**From:** Richard Gehus  
**To:** Tim Maybee; Stephen Booth; Linda Butler; Randy Jenco; Martin Pohl; Mimi Morris  
**Cc:** Amelia Wilder; John Merchant  
**Subject:** Concerns about the draft Integrated Water Master Plan  
**Date:** Monday, November 18, 2024 11:06:53 AM  
**Attachments:** IWMP+Revert+Figure 5-5.png

The figures that I mentioned (Figures 5-5, 5-6, 5-7, 5-8, and probably others) seem to all be obviously off by three or four months. Below, is a copy of Figure 5-5, with three vertical red lines that I have added.

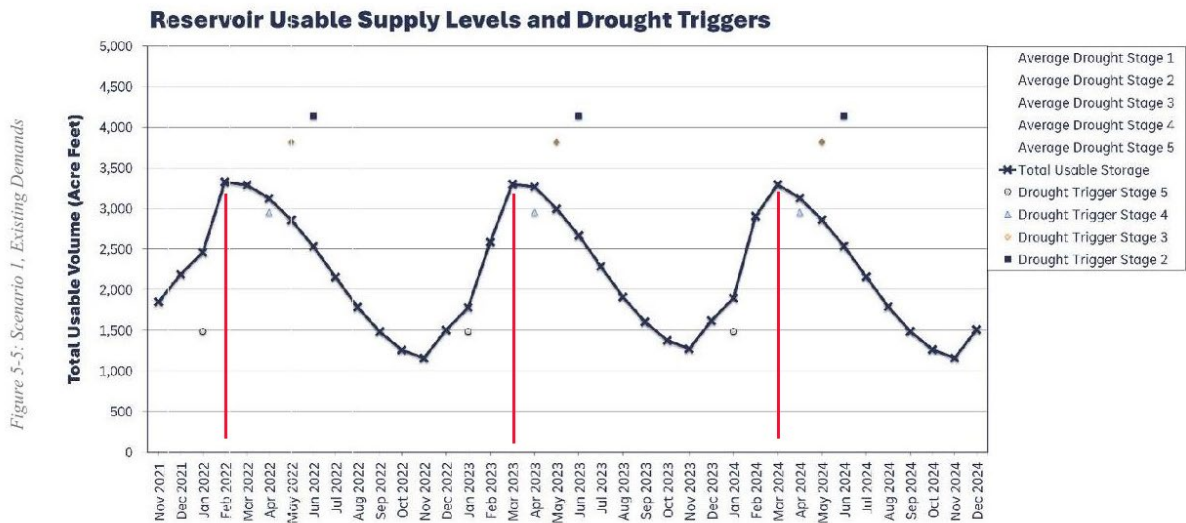
They have included charts in the draft IWMP (Figures 5-5, 5-6, 5-7, 5-8, and probably others) that are simply WRONG.

For anybody that is familiar with the source of water for our reservoirs and who looks critically at these charts **THEY ARE VERY OBVIOUSLY WRONG** and it sticks out like a sore thumb when you are aware of it.

To state the obvious, the water in the reservoirs reflected in these figures are usually (if not always) at their maximum on May 31 of the year - the end of the pumping season when CSD makes sure the reservoirs are at their maximum level. However, the figures in the draft IWMP show the maximum levels in February and March! This seems obviously wrong to me.

These number are as expected. The Figures in the draft IWMP do not reflect this.

This is not acceptable and I think we need an explanation from Adkins/Maddaus. Are these just fake/dummy figures that they threw into the IWMP hoping that nobody would notice? Does this actually reflect the data that they are using, which would make us completely question their results? Or what?
